U.S. Department of the Interior BUREAU OF LAND MANAGEMENT Sundry Print Report

Sundry ID: 2654238

Type of Action: Plug and Abandonment

Ballard 4

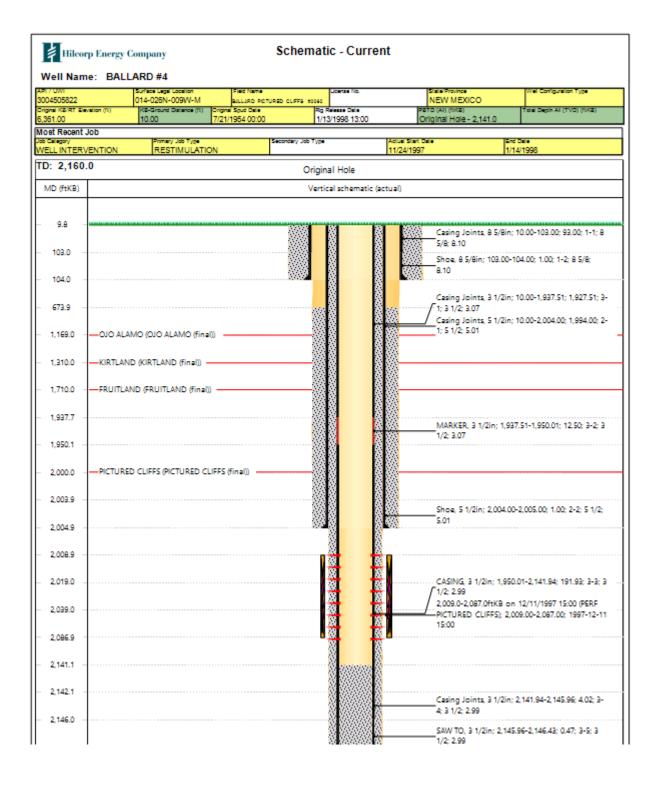
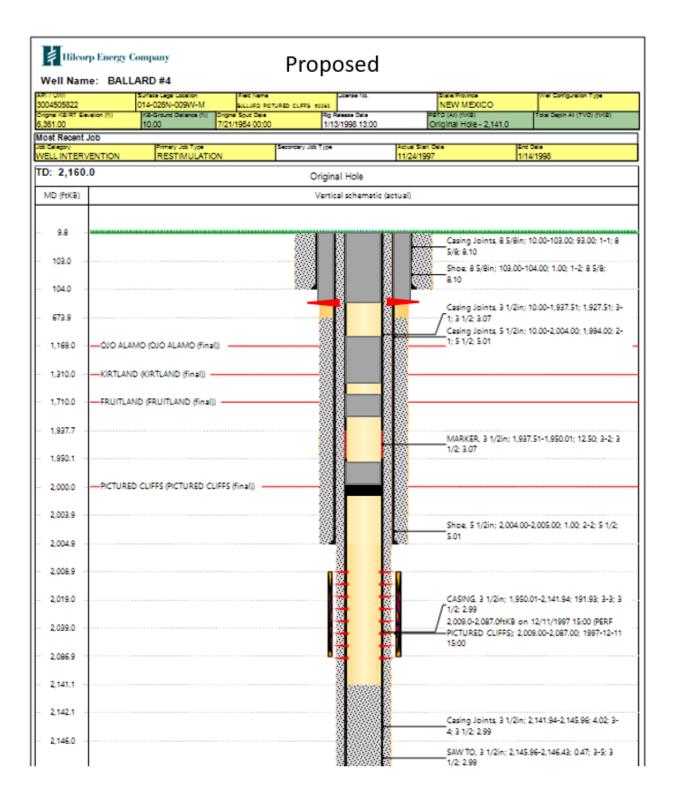
- Tops for this well were estimated using logs from Reference Well #1.
- BLM estimates for the Fruitland and Ojo Alamo formation tops vary from Operator submission.
- Bring the bottom of Plug #2 (Fruitland) down to 1805' to cover BLM formation top estimate (1755').
- The plugs proposed in the P&A procedure, with recommended changes, will adequately protect any freshwater sands in this well bore.
- Pictured Cliffs perfs 2009' 2087'.

- 1. Plugging operations authorized are subject to the attached "General Requirements for Permanent Abandonment of Wells on Federal and Indian Lease."
- 2. The following modifications to your plugging program are to be made:
 - a) Increase the volume of cement above Plug #1 (Pictured Cliffs) to 50' of cement on top of the CIBP.
 - b) Bring the bottom of Plug #2 (Fruitland) down to 1805' to cover BLM formation top estimate (1755'),
- 3. Farmington Office is to be notified at least 24 hours before the plugging operations commence at (505) 564-7750.
